Value Engineering Report  
Design Development Stage

**STP-9252(6) and STP-9250(1)  
JOHNSON FERRY AND ABERNATHY ROADS  
WIDENING FROM THE  
CHATTAHOOCHEE RIVER TO ROSWELL ROAD  
P. I. Nos. 751300 and 715310  
Cobb and Fulton Counties, Georgia**

December 2006

**Georgia Department of Transportation  
District 7**

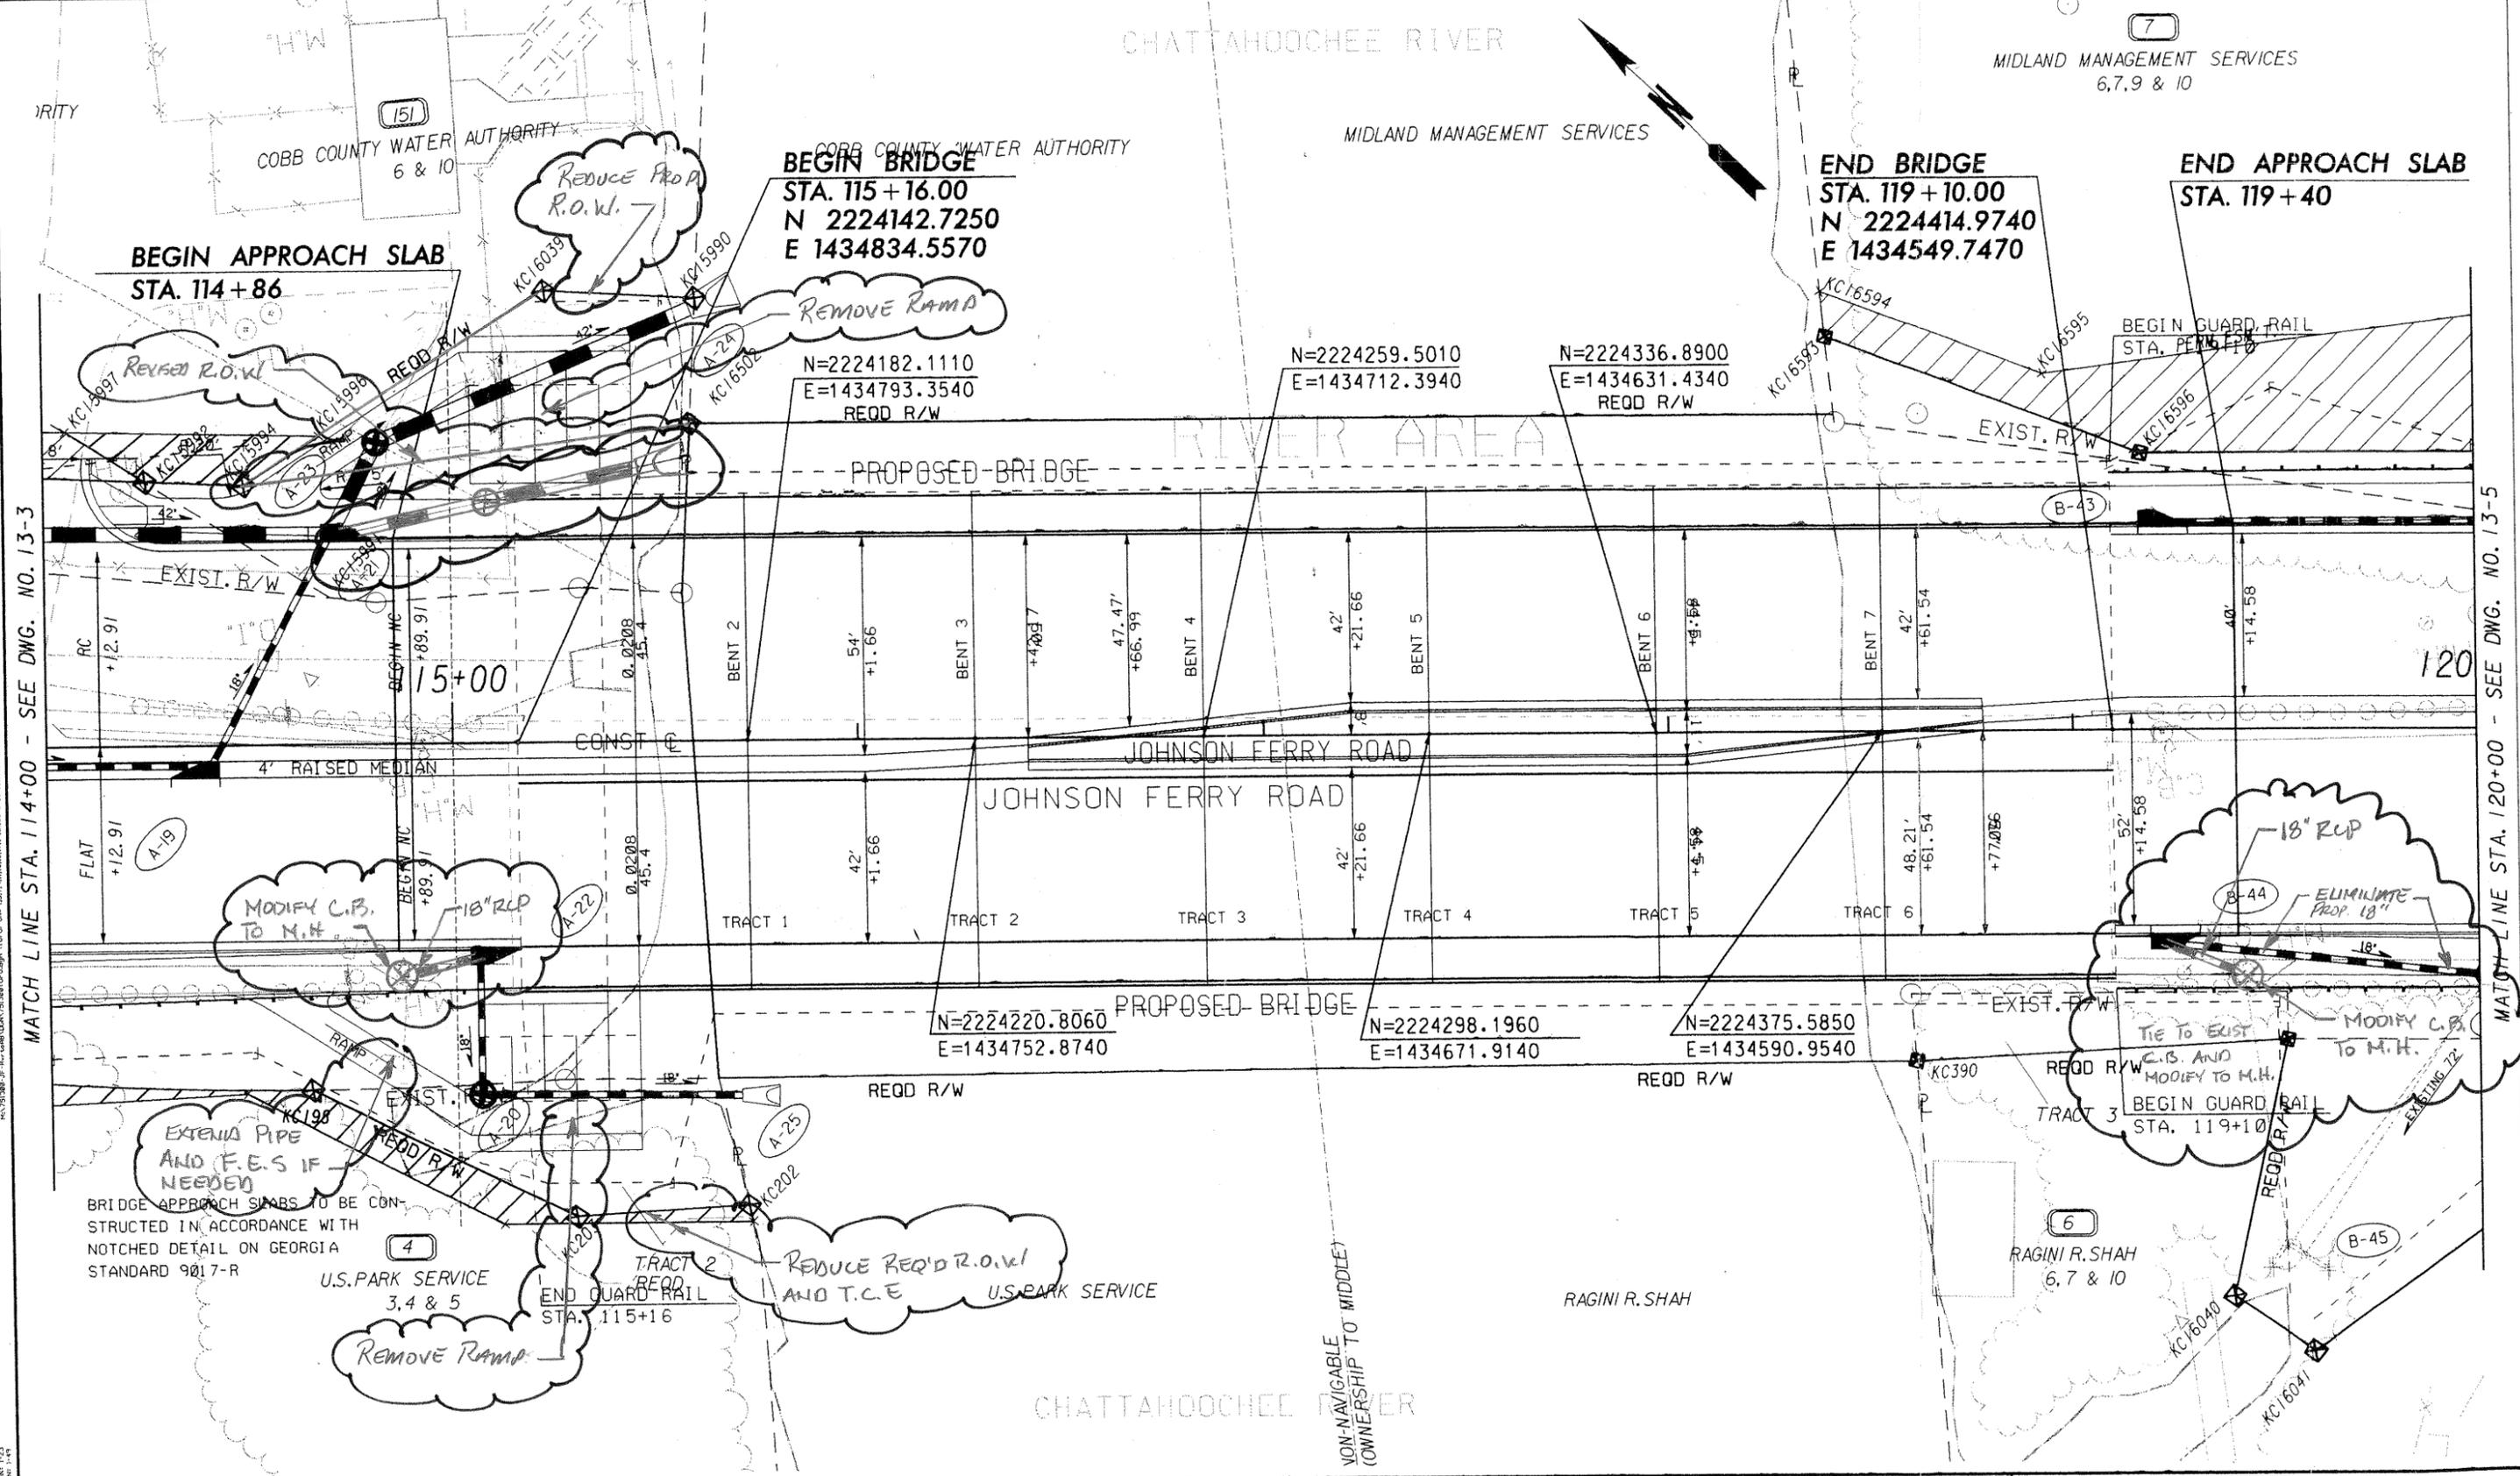
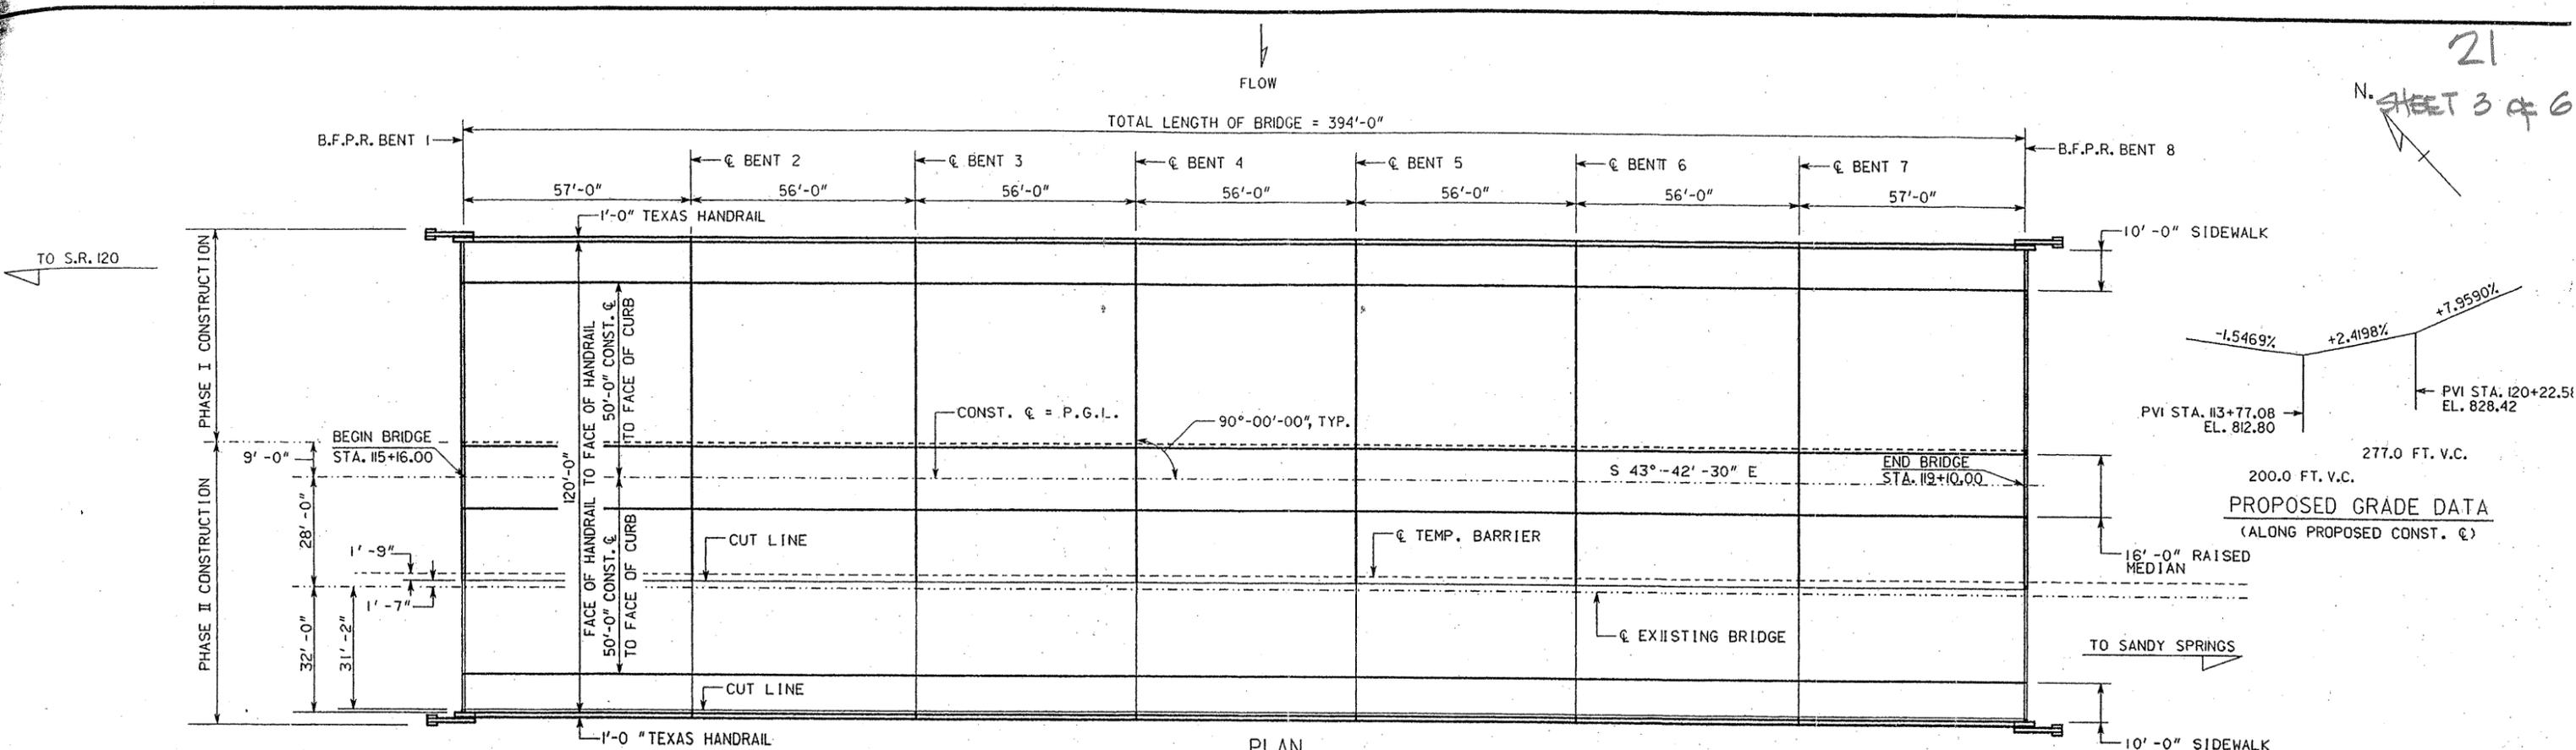
The current design indicates the use of pedestrian ramps on both the left and right sides of the roadway to cross beneath the Johnson Ferry Road bridge on the north side of the River. The plan also proposes a pipe to be located under each ramp well.

Eliminate the underpass walkway connecting the Chattahoochee River National Recreation Area and Columns Drive on the north side of the Chattahoochee River. The proposed pipe underneath the pedestrian ramps are to be modified and relocated to be maintained within the existing right-of-way on the right side and within a smaller portion of the required right-of-way on the left side of the bridge.

- Does not accommodate previously agreed-to CAC request for 8-foot sidewalks
- Loss of a perceived amenity
- Perceived reduction in pedestrian safety

The Johnson Ferry Road bridge is being designed with wider sidewalks on both sides. The proposed pedestrian underpass will not provide a significant advantage with the nearness of the Columns Drive and Johnson Ferry Road intersection that already has an at-grade pedestrian crossing that provides safe passage for pedestrians and recreational area users.
